RENESAS TECHNICAL UPDATE

Product Category	System LSI		Document No.	TN-RCV-A0001A/E	Rev.	1.00
Title	R-CarV3M Addition of section 19:Booting		Information Category	Technical Notification		
Applicable Product	R-Car V3M (R8A77970)	Lot No.	Reference Document	R-Car V3M R-Car Series 3rd Generation User's Manual: Rev.3.50 Jan 25, 2022 (R19UH0114EJ0350)		
		All Lots

Addition of section 19:Booting

Figure 19.2 Master Boot processor selection

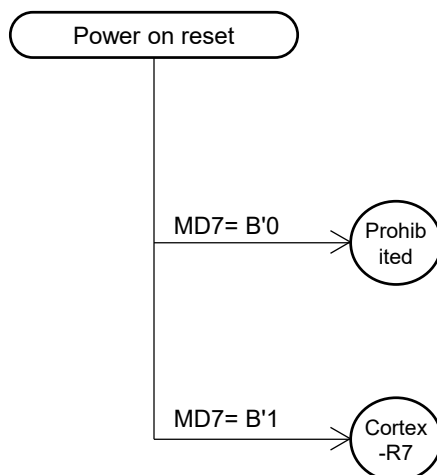
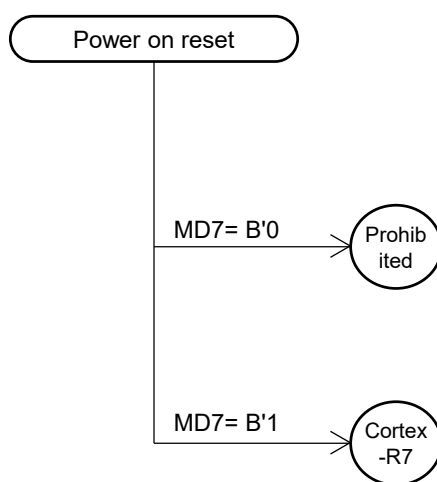
Add a notice for XIP mode boot.

RPC-IF restriction was found.

Notice : Because of RPC-IF restriction, CPU should read with 16Byte alignment to Hyperflash in XIP mode boot.
